RIVIERE DU CHIEN WOODS SUBDIVISION, **LLOYD STATION UNIT, LIPSCOMB-JONES** **ADDITION TO**

APPLICATION NUMBER 13 DATE April 3, 2003

REQUEST Subdivision

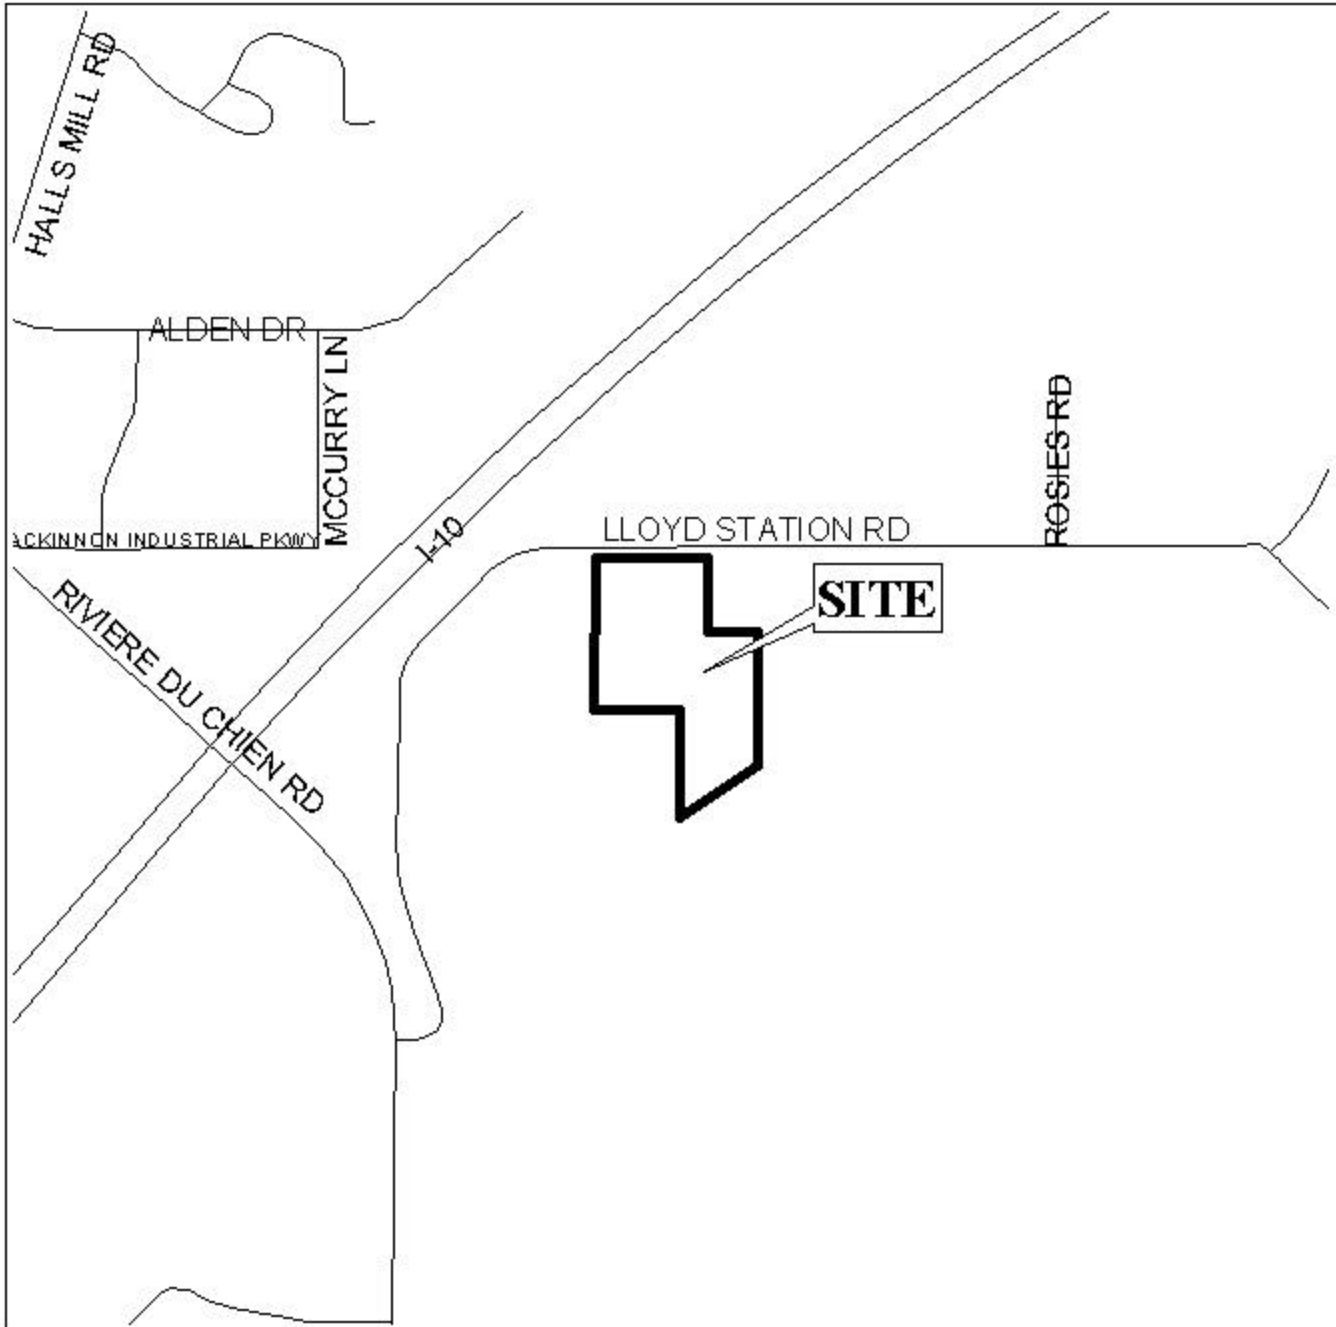
As illustrated on the plat, the subdivision consists of nine-lots; three lots are fronting Lloyds Station Road and the remaining lots will front a private street. While the Subdivision Regulations allow a maximum of five lots on a private street, the Court required the division of property as submitted.

The proposed development consists of two families dividing property and would only exceed the number of lots allowed on a private street by one lot. The three lots fronting Lloyds Station Road must be denied access to the private street. Additionally, the private street must be constructed to private street standards as outlined in Section VIII.E.2. of the Subdivision Regulations, including the submission of all necessary engineering documentation and certifications prior to the recording of Lots B, C, D, E, F and J.

With modifications, the plat will meet the minimum requirements of the Subdivision Regulations and is recommended for Tentative Approval subject to the following conditions: 1) the placement of a note on the final plat stating that Lots A, G and H are denied access to the private street; and 2) that the private street be constructed to the standards as set forth in Section VIII.E.2. of the Subdivision Regulations, including the submission of all necessary engineering documentation and certifications prior to the recording of Lots B, C, D, E, F and J.

DETAIL SITE PLAN

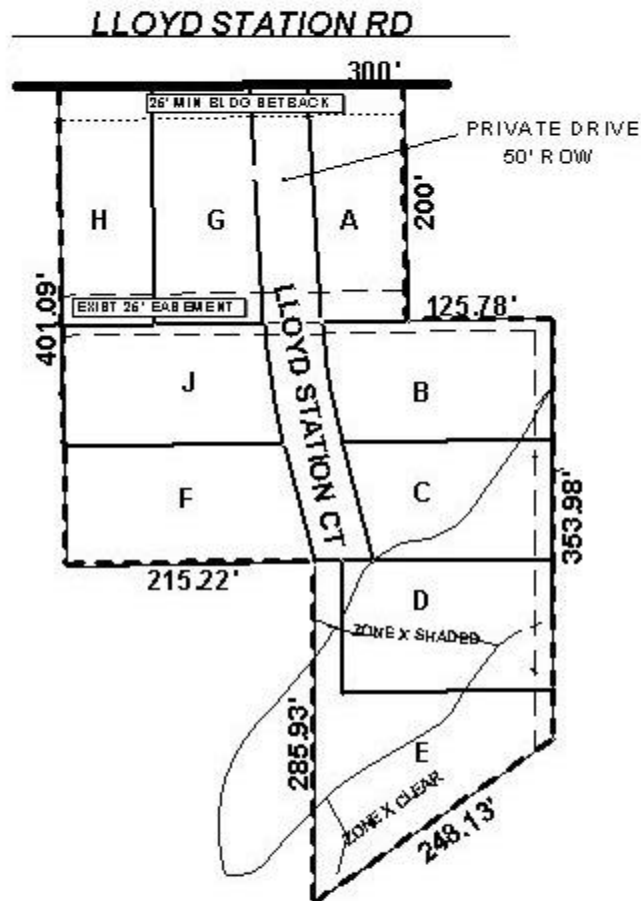
Engineering Comments: No City of Mobile maintained outfall available for storm water drainage. Therefore, storm water detention for 100-year storm with 10-year release rate will be required. Stormwater release onto adjacent property cannot be increased or concentrated without a hold harmless agreement from adjacent property owners. Development of property must comply with all stormwater management and flood control ordinances. Any work performed in the right-of-way will require a right-of-way permit.

Traffic Engineering Comments: Driveway number, size, location and design to be approved by Traffic Engineering and conform to AASHTO standards.
